BCC DS
RECEIVED
13-NOV-2026
APPLICATION REF
A007151233

RE: MINOR CHANGE APPLICATION TO DEVELOPMENT APPROVAL A005732929

Applicant	Derry Developments Pty Ltd C/- The Development Directive Pty Ltd
Land Owner	Derry Developments Pty Ltd
Application Number	A005732929
Application Address	32 Jennifer Street, Seventeen Mile Rocks QLD 4073
Property Description	Lot 1 on RP95505

Figure 1: Building B – Sub-floor plan

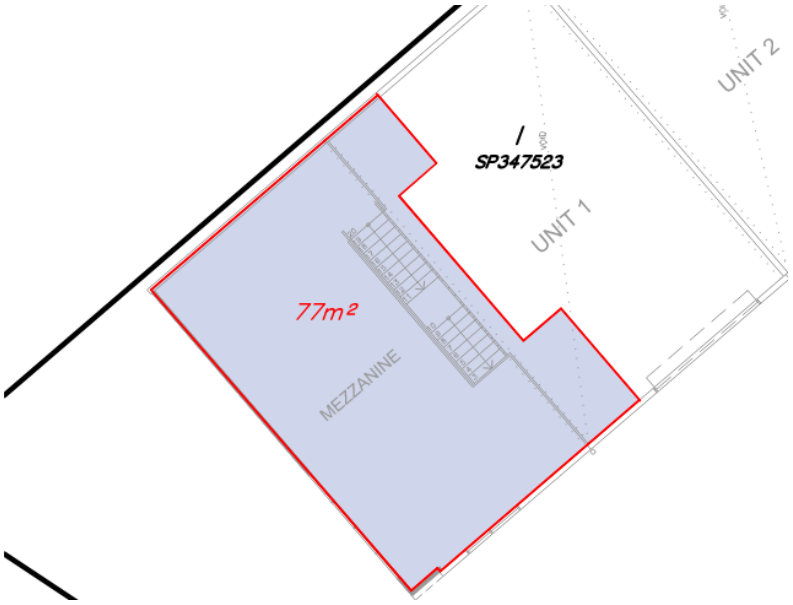
Unit 1 of the development incorporates a minor increase to the extent of mezzanine. The extent of increase to the mezzanine is illustrated under Figure 1.

Figure 2: Building B – Sub-floor plan

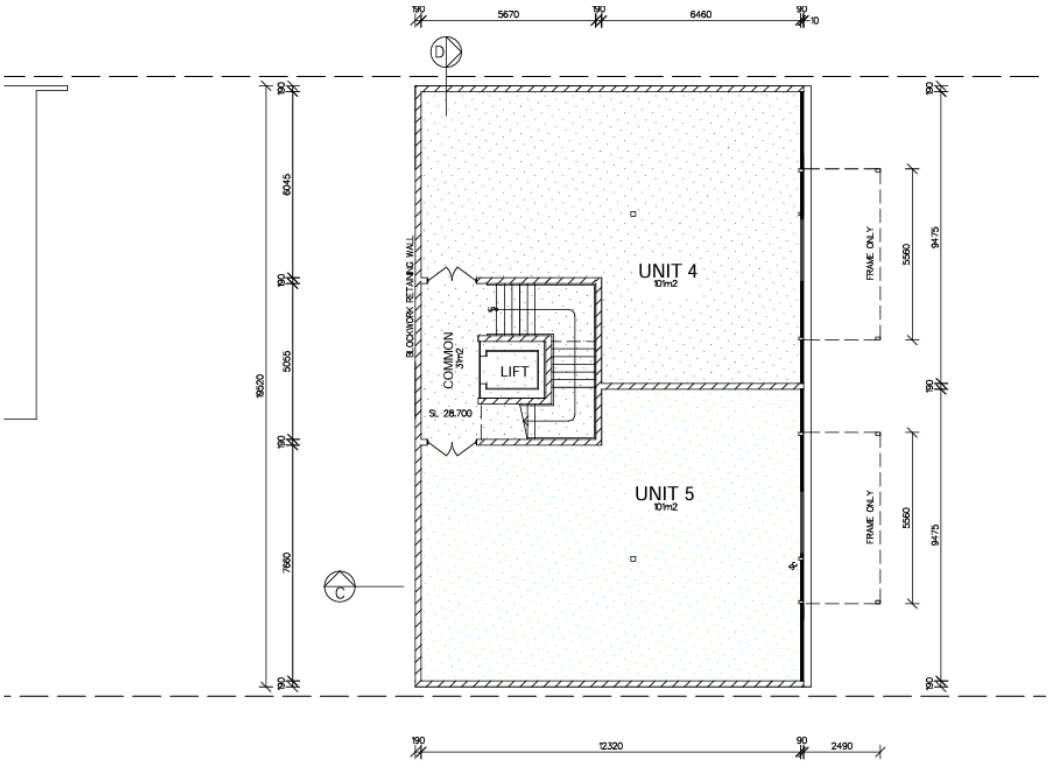
The Applicant also seeks to amend the Warehouse Building B floor plans to include a sub-floor storage level for Unit 4 and Unit 5 below the ground floor level. This level contains an additional 202m^2 of gross floor area (across the two tenancies) and will be exclusively used for additional storage for the future tenants. The operation of the site does not change despite the increased floor area and therefore, there will be no additional demand on the transport network. Ultimately, the proposal seeks to make use of the approved extent of undercroft which would otherwise be underutilised.

Figure 4: Proposed Building B Rear Elevation

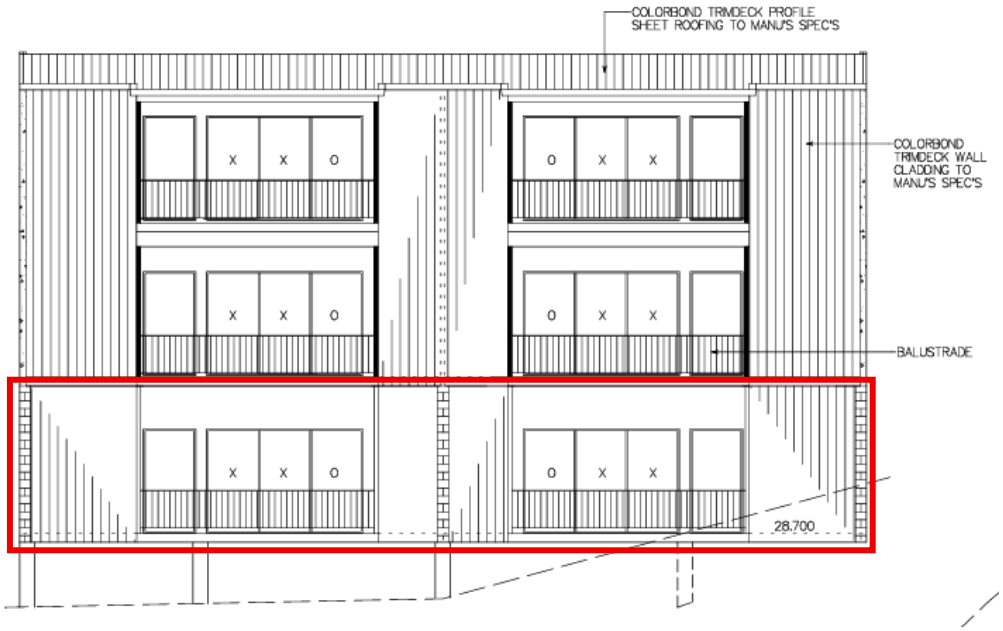
As a result of detailed design and due to the introduction of the sub-floor area, there is a very minor increase to the maximum building height for Building B. In particular, it is proposed to increase the building height from 7.57m to 7.61m in height, which is an overall increase in 4cm. Refer to Figure 3 and 4 below for a comparison between the approved and proposed Building B rear elevation.

Figure 8: Proposed side elevation

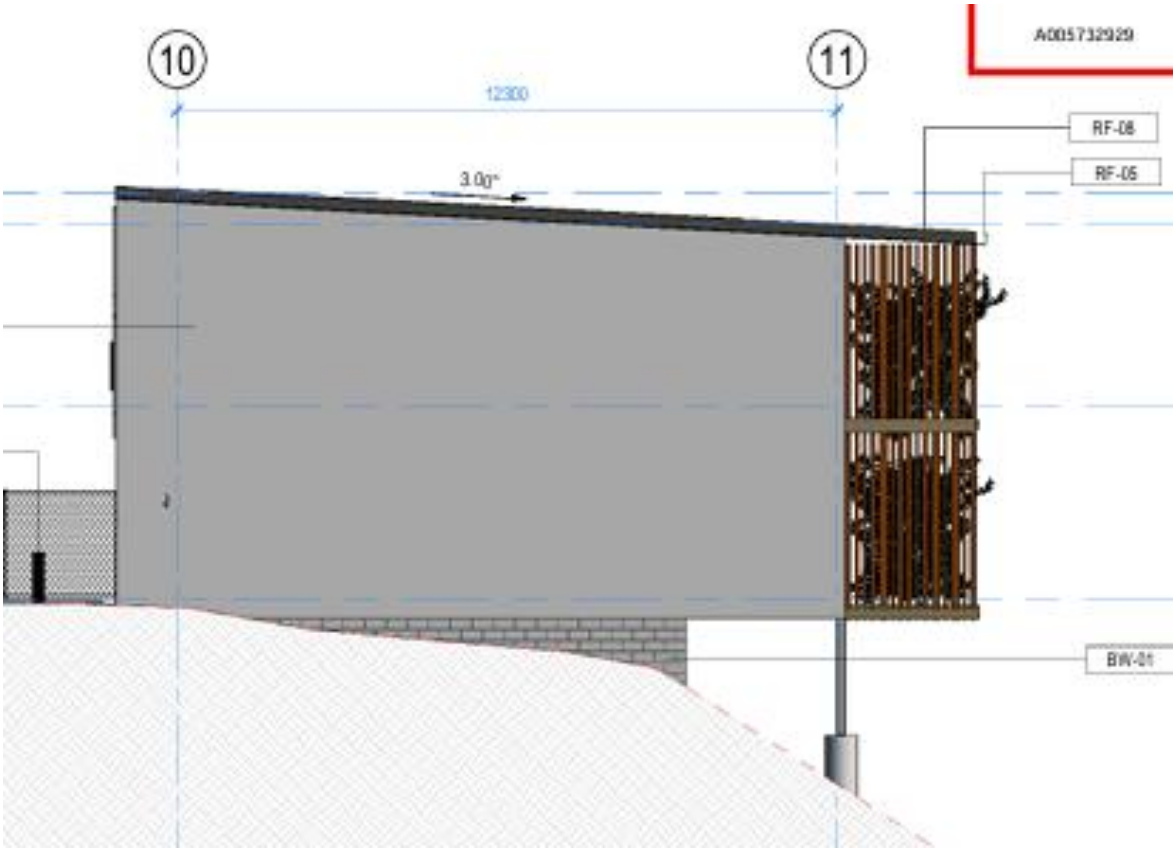
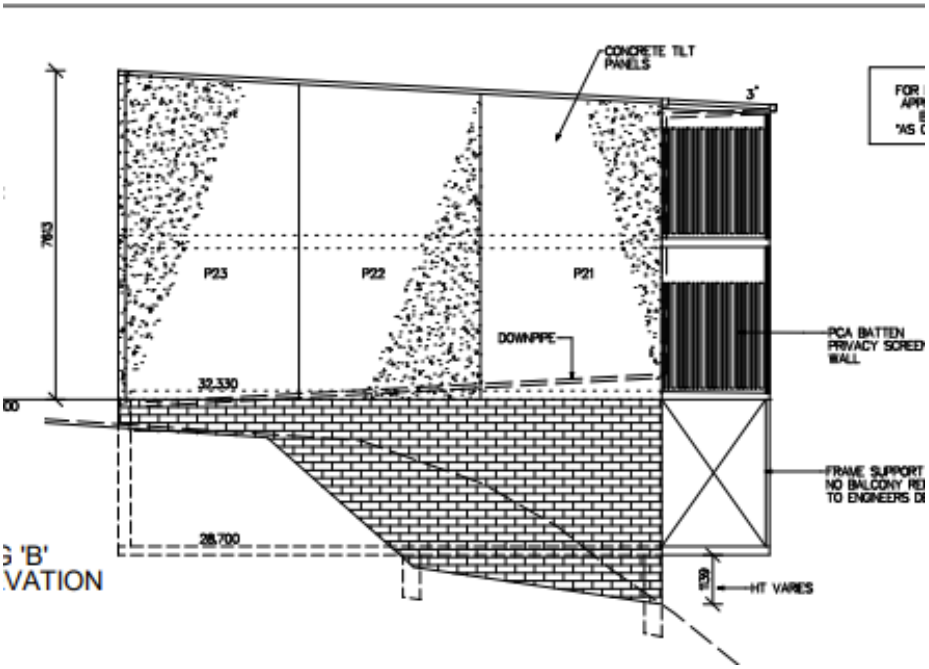
Moreover, when viewed from Jennifer Street, there is no change to the appearance of the building in terms of bulk and scale and as illustrated under Figure 7 and Figure 8, when viewed from neighbouring properties the building appears consistent with the approved plans.

Figure 10: Proposed Landscaping Outcome

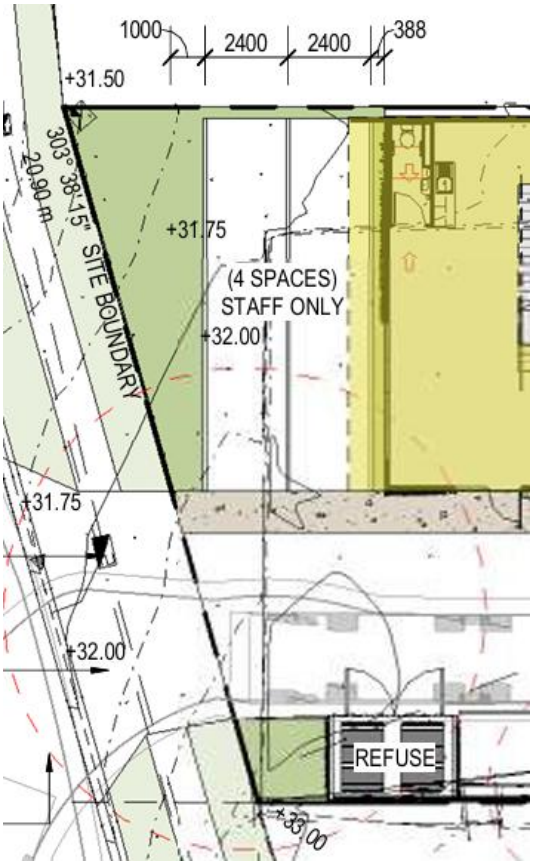
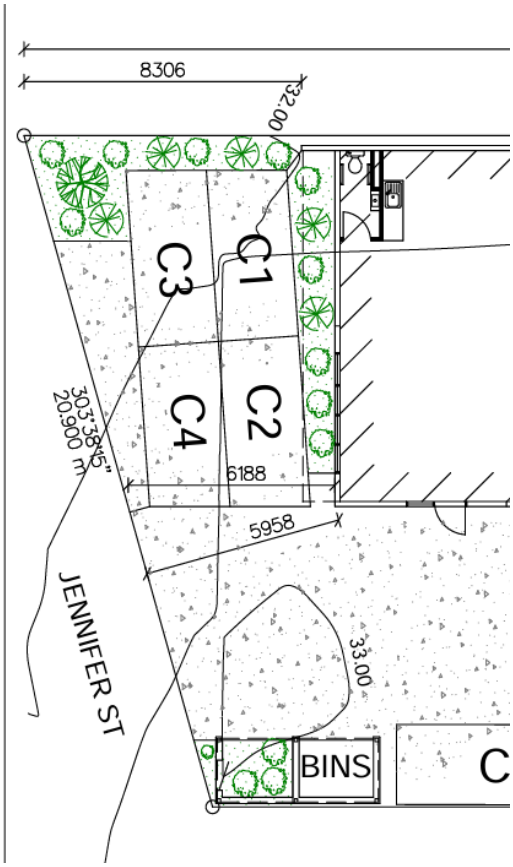
The front car parking area has been slightly amended which requires a minor change to the landscaping area in this location. The change allows for parking areas to grade into the approved stormwater solution. In particular, it is proposed to relocate a landscape strip between the car parking area and Building A, instead of it being between the car parking area and the road verge. Furthermore, the landscaping buffer along the northern-western boundary has slightly increased (refer to Figure 9 & 10 below).

While the proposed landscaping changes result in a reduction of approximately 10m² of landscaped area, the site will retain approximately 35% landscaping coverage overall. This represents a significant proportion of the site and is considered appropriate within the context of industrial development.
